**CONSTRUCTION BULLETIN
No. 1**

Institution: Calipatria State Prison - CAL

Reference: Project #18-045, Replace Roof, Phase 11, including

Description: This bulletin is to revise the roof slope to the existing ¼” per foot and to revise the parallel AHU’s crickets to 1 ½” per foot on the upper roof per RFI 003 response. Plans and Sections have been revised show the updated roof slope. Parapet,

GA4.1

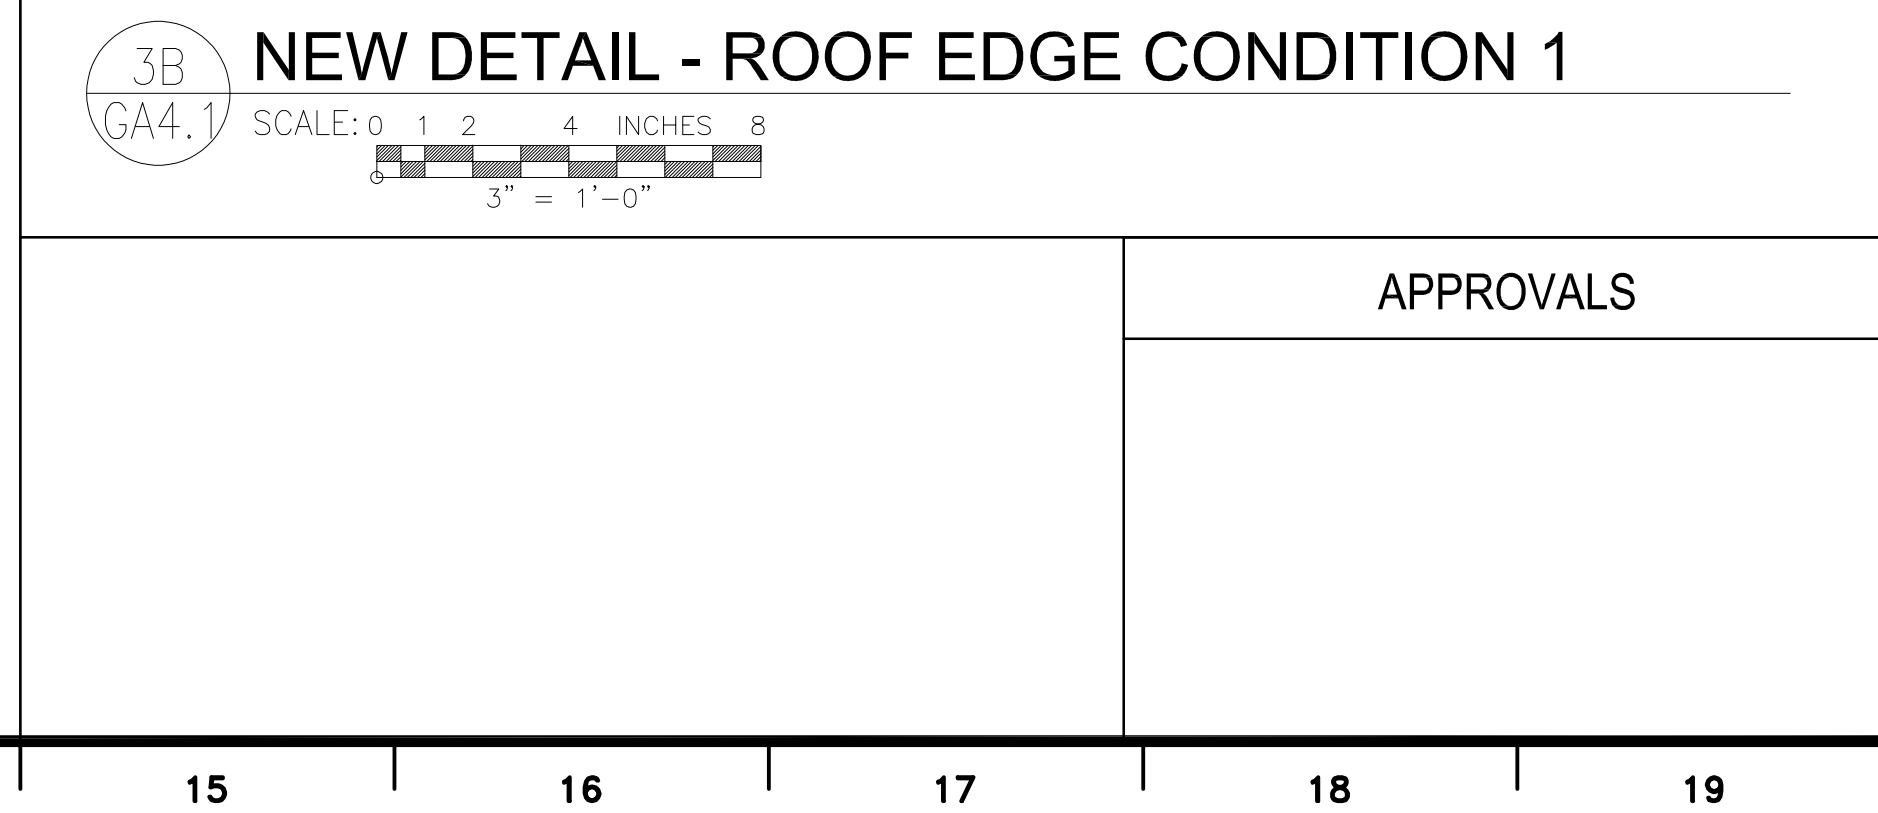
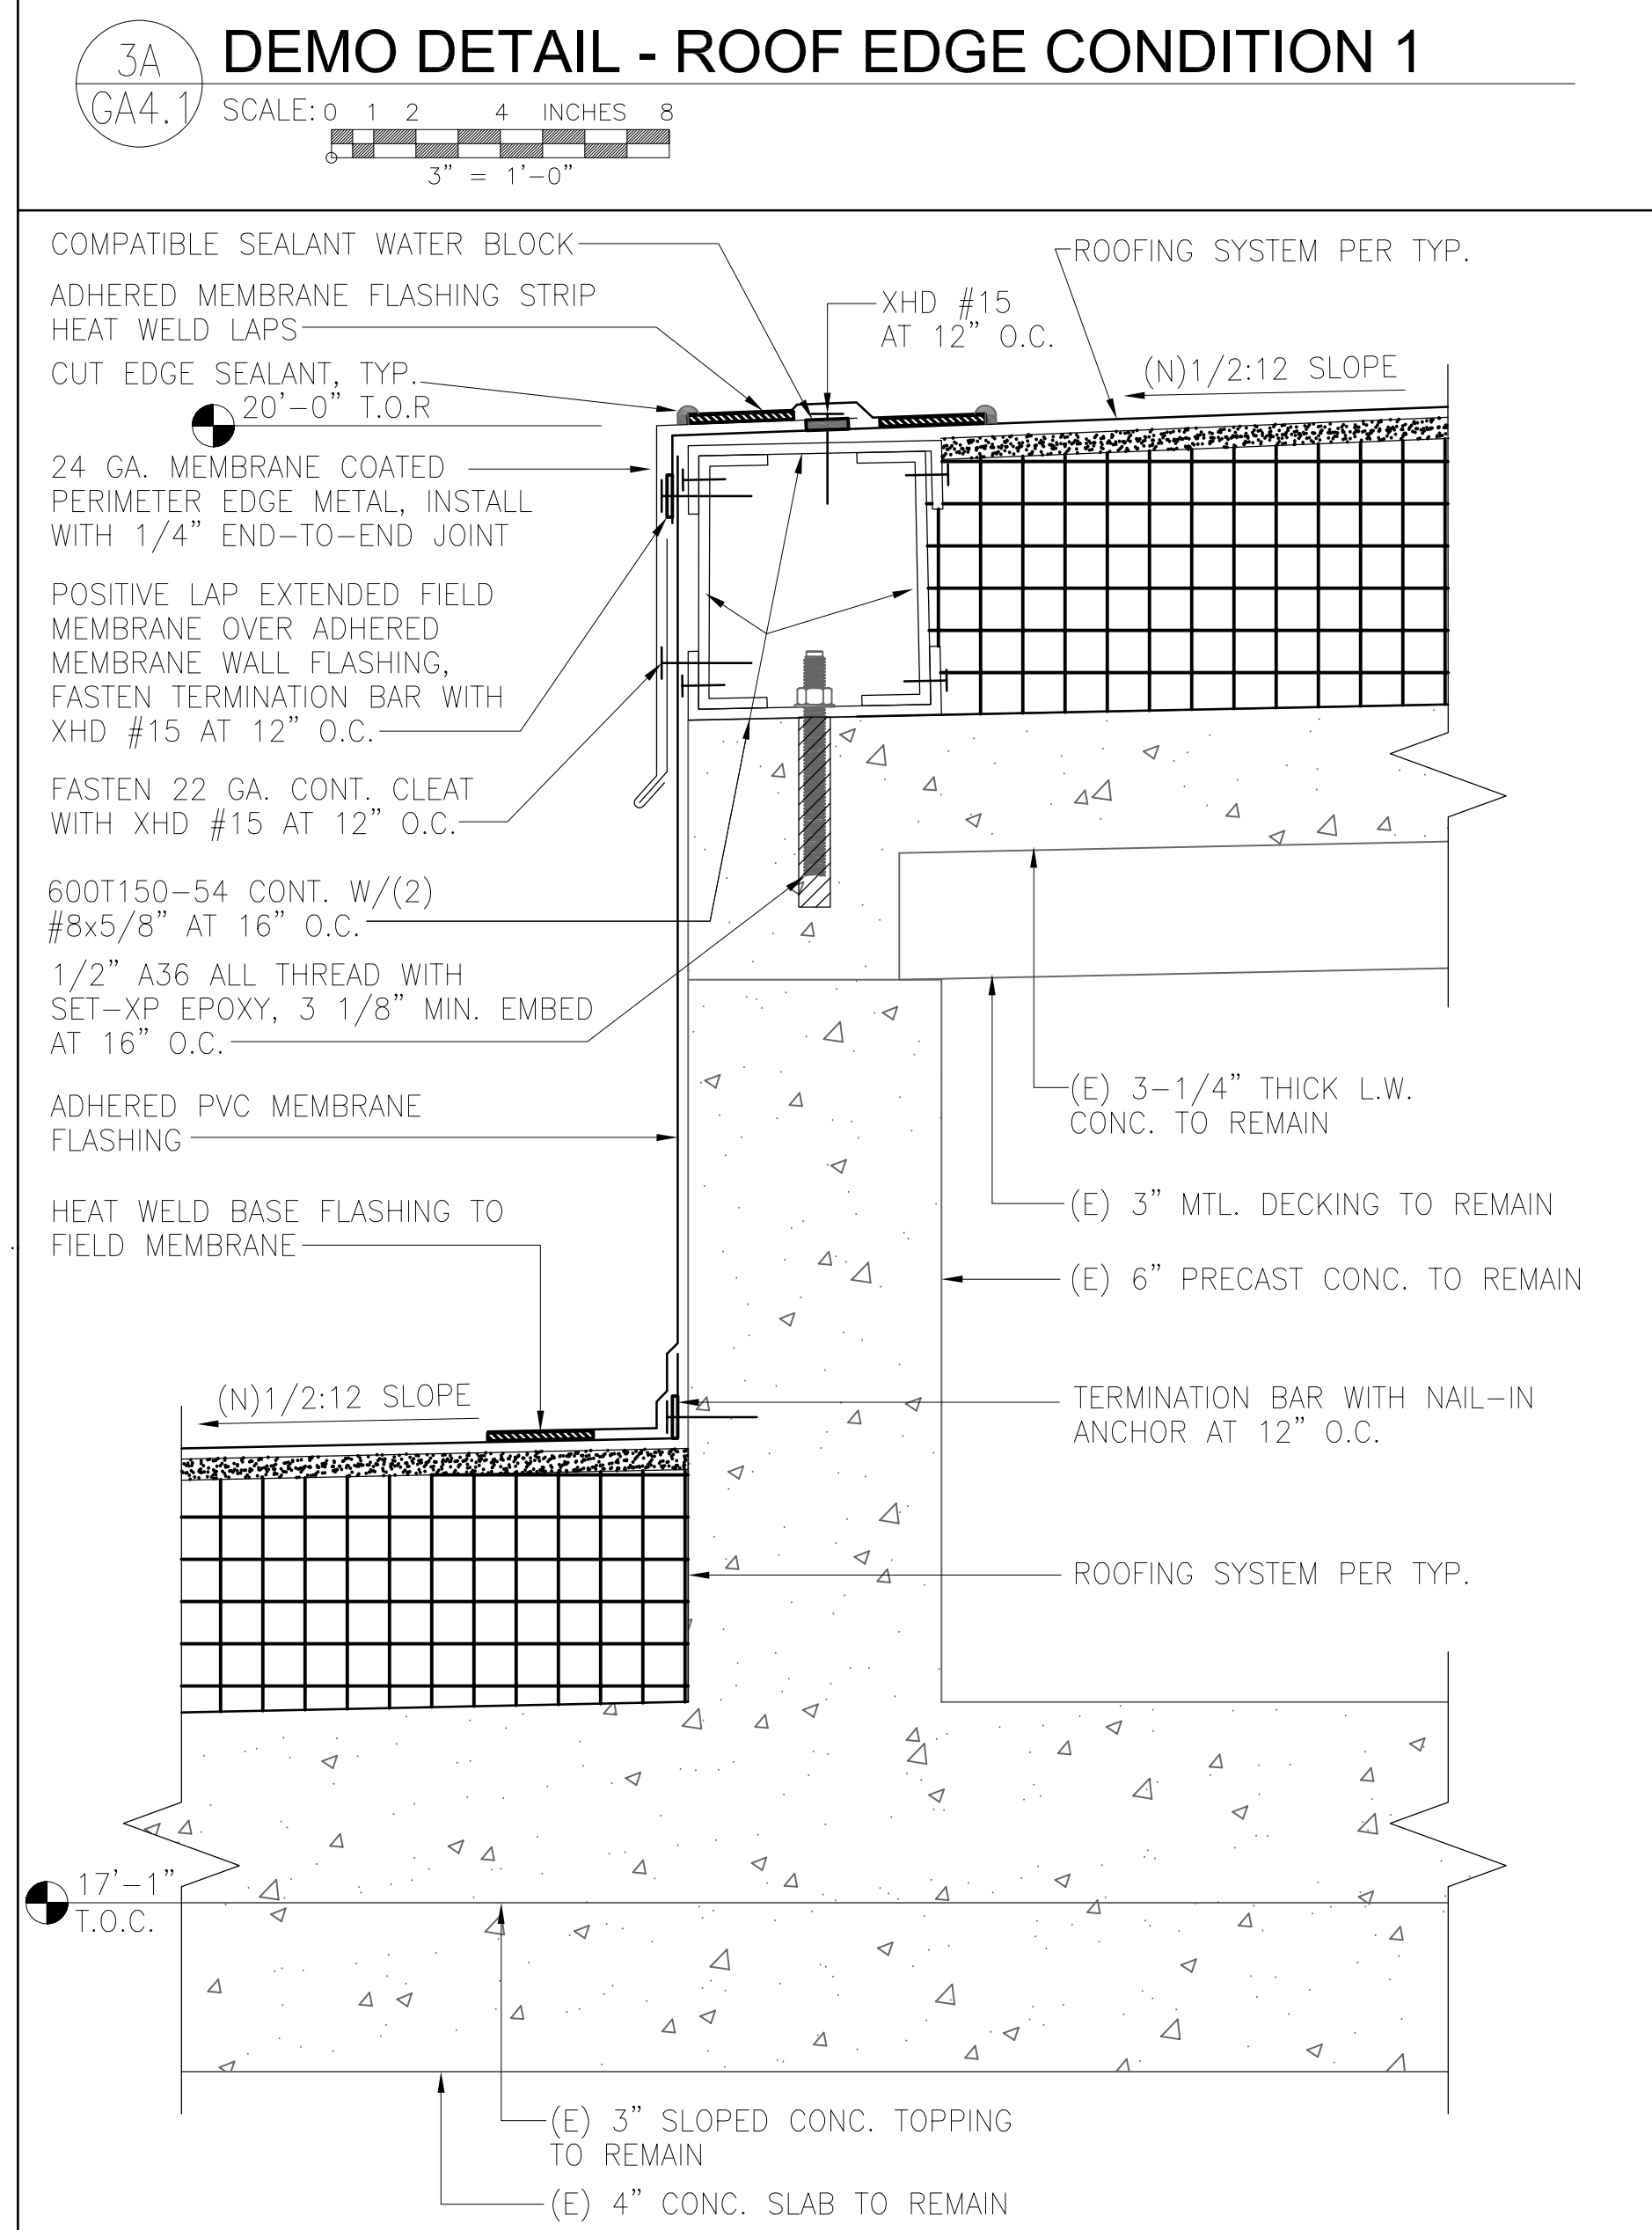
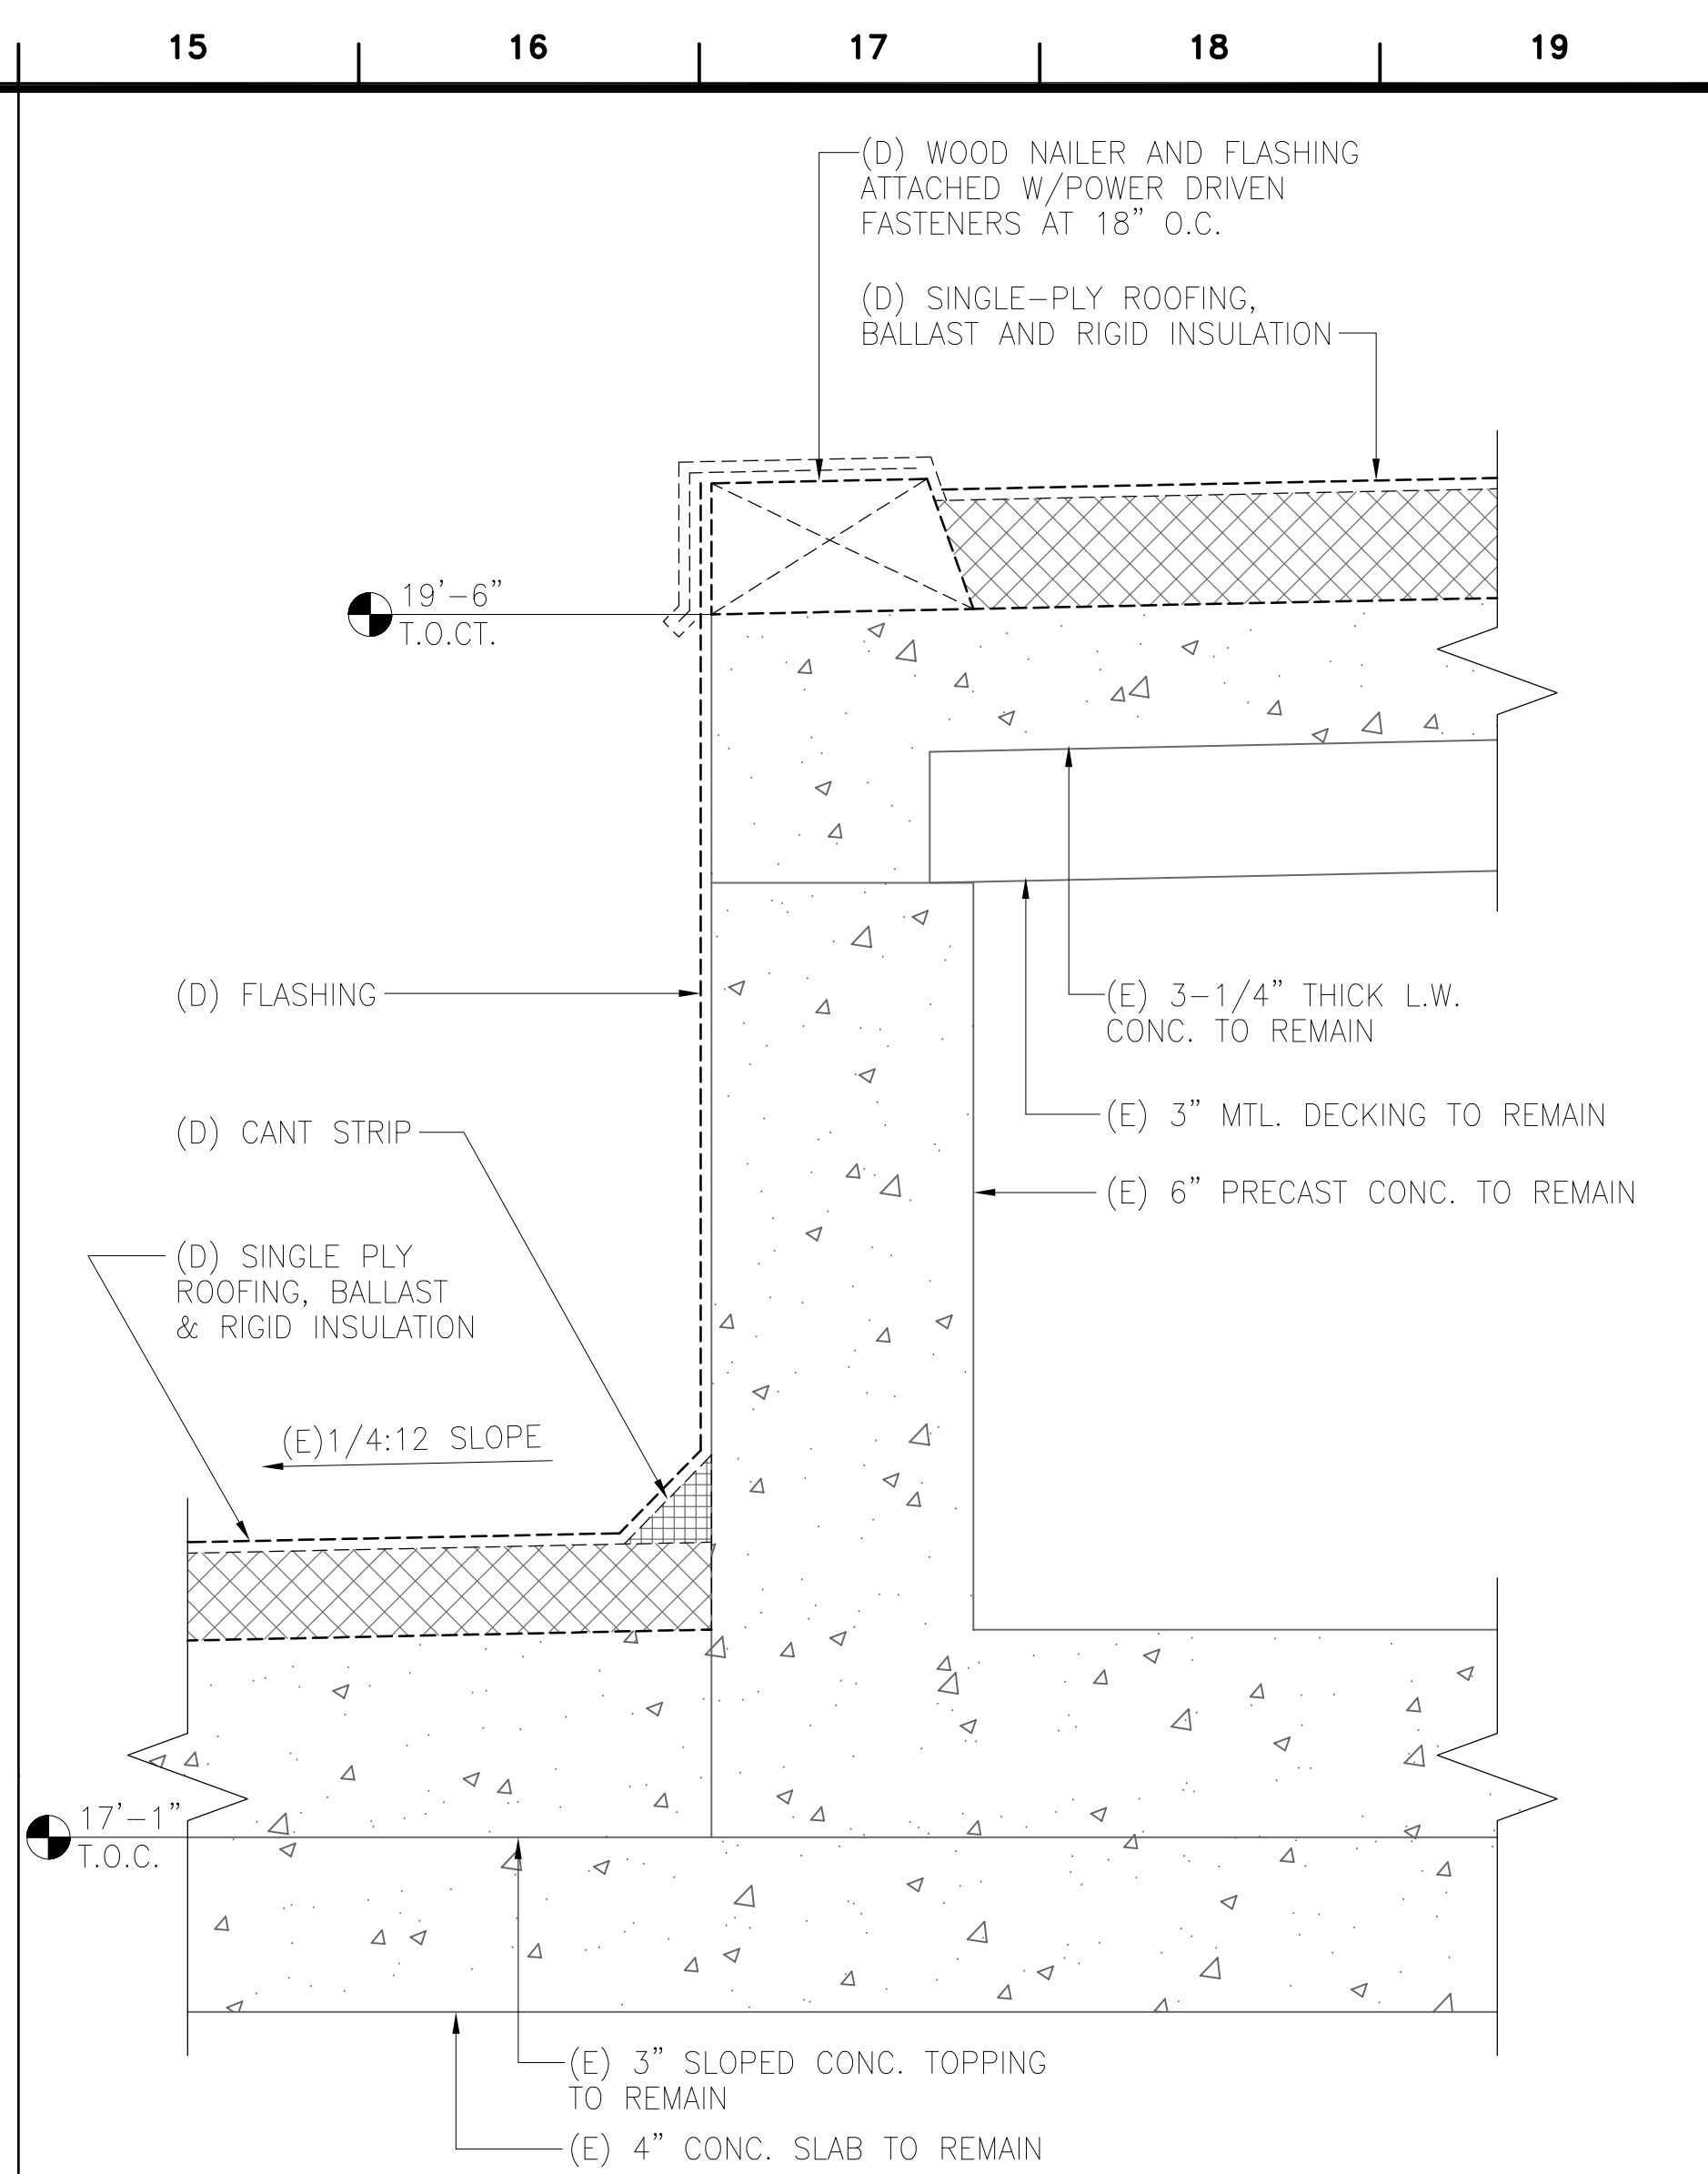
- a. Revised parapet detail to reduce parapet height per reduction of roof slope. See detail 1B/GA4.1.
8. Sheet GA4.2:
 - a. Revised roof edge condition detail per revised roof slope, see detail 3/GA4.2 and 5B/GA4.2.
